FINAL DECISION
Energex determination 2015–16
to 2019–20

Attachment 6 – Capital
expenditure

October 2015

Figure B.10 New connection quantities – 2005–06 to 2019–20

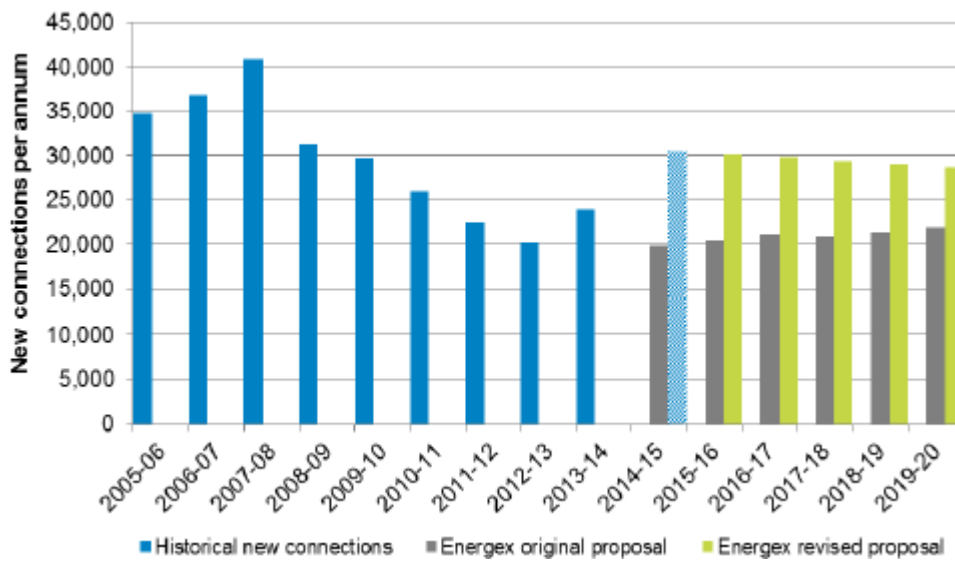
In its revised proposal, Energex submit that connection activity has shown a stronger recovery than previously expected.¹⁸⁶ Energex has provided updated actual volumes of new connections to the end of April 2015. As shown in Figure , when extrapolated to the end of 2014–15, Energex now expects 30,486 new connections for the year.

Figure B.111 HIA housing actual and forecast dwelling starts for Energex distribution area Queensland – 2015

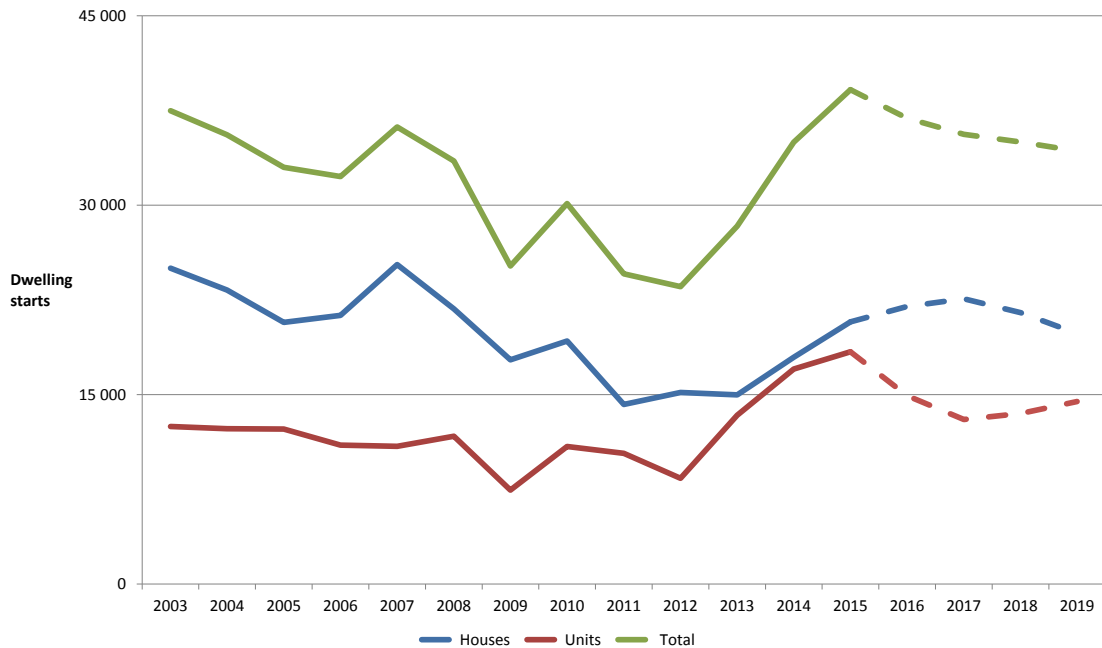
Figure shows house and unit construction starts in Energex’s distribution area since 2003. It shows that Energex’s recent connections activity is consistent with dwelling starts and its forecast is consistent with the HIA expenditure trend.

Figure B.12 Commercial project quantities 2005-06 to 2019-20

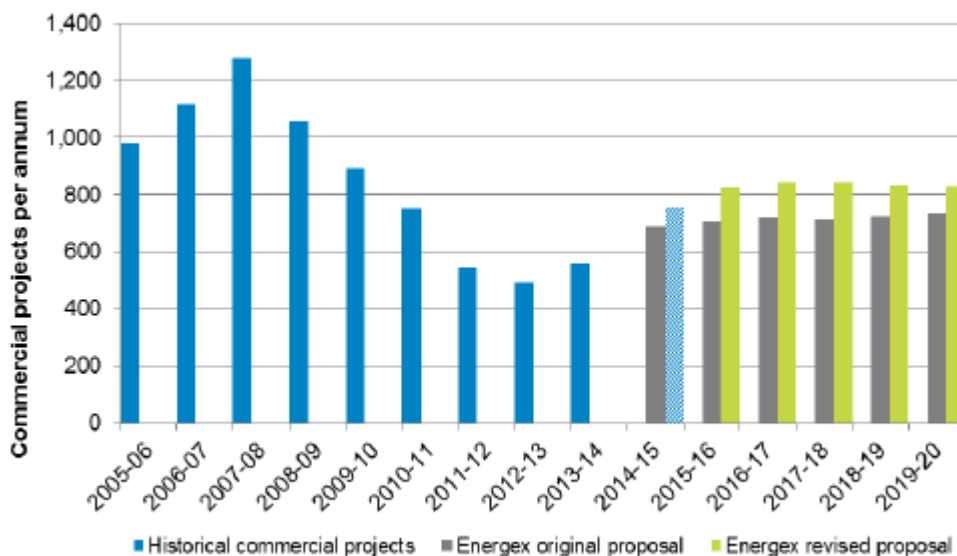
As for new service connection activity, Energex has prepared updated forecasts of commercial project activity since the original proposal was submitted. In 2013–14 there were signs that the decline in commercial project activity in preceding years had slowed, which indicated an emerging recovery. The latest reported data adds further support to the view of a recovering commercial market. The 2014–15 data indicates a modest, but enduring, upwards trend in projects per month.¹⁹¹

Importantly, Energex stated that “it is reasonable to assume that 2014–15 levels of connection activity are likely to be maintained in broad terms over the whole 2015–20 regulatory control period.”¹⁹² However, as shown in Figure , in forecasting its expenditure, it has included additional forecast growth in volumes in 2015–16, and then maintained this level for the remainder of the 2015–20 regulatory control period.

Figure B.13 Energex's repex – historic actual and revised proposed for 2015–20 regulatory control period (real \$ million 2014–2015)

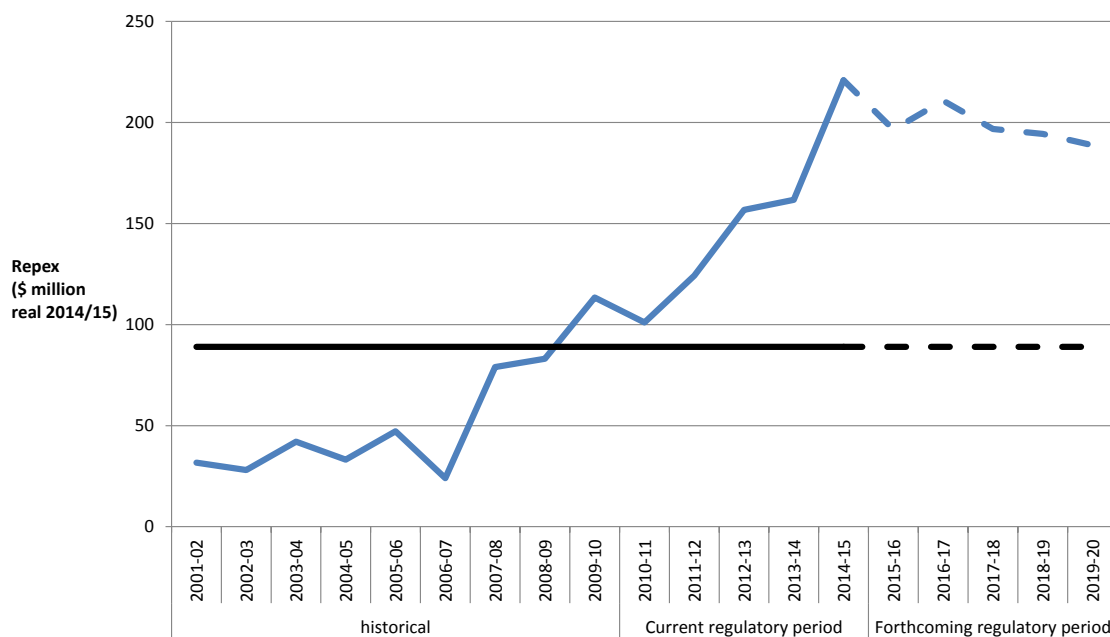
Figure below indicates that Energex's revised repex proposal for the 2015–20 regulatory control period is well above that incurred in the previous regulatory control period and the early 2000s.

Figure B.14 Actual and expected repex (\$ million real June 2015)

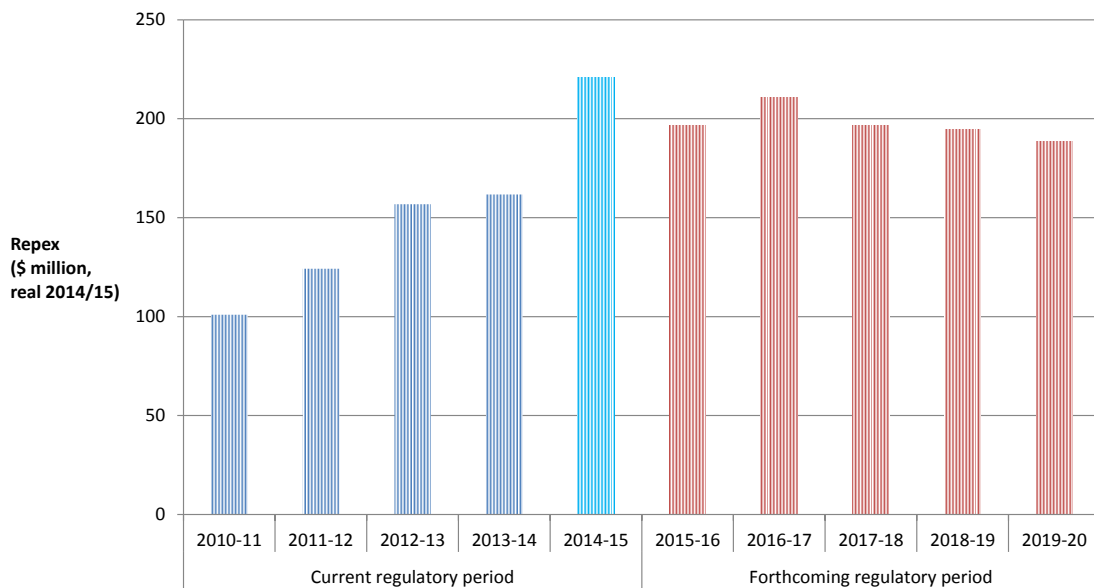
Figure B compares actual and expected repex in the current and forthcoming regulatory control period.

Figure C.3 Energex maximum demand forecasts between 2008 and 2014

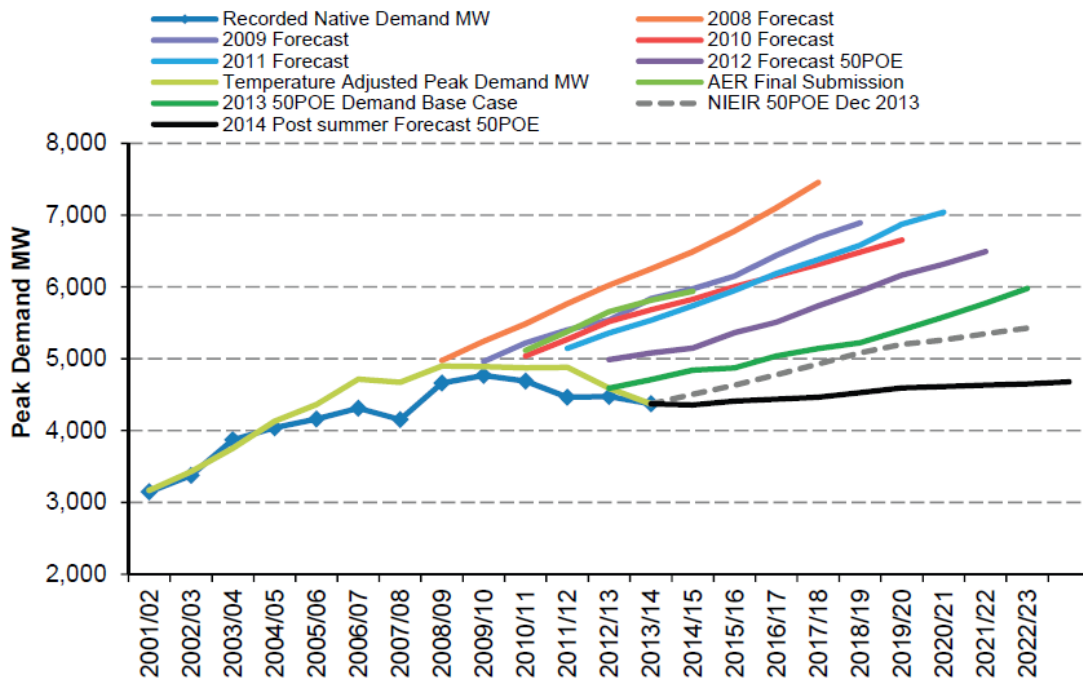
The recent trend in demand forecasts across the NEM is that demand forecasts are actually progressively downgraded over time as actual demand is lower than previously forecast as forecasting methods improve. Energex follows this pattern because it is forecasting low demand growth over the 2015–20 period and it has been progressively downgrading its forecasts since its regulatory proposal for the 2010–15 period. This is reflected in the following chart taken from Energex’s distribution annual planning report.
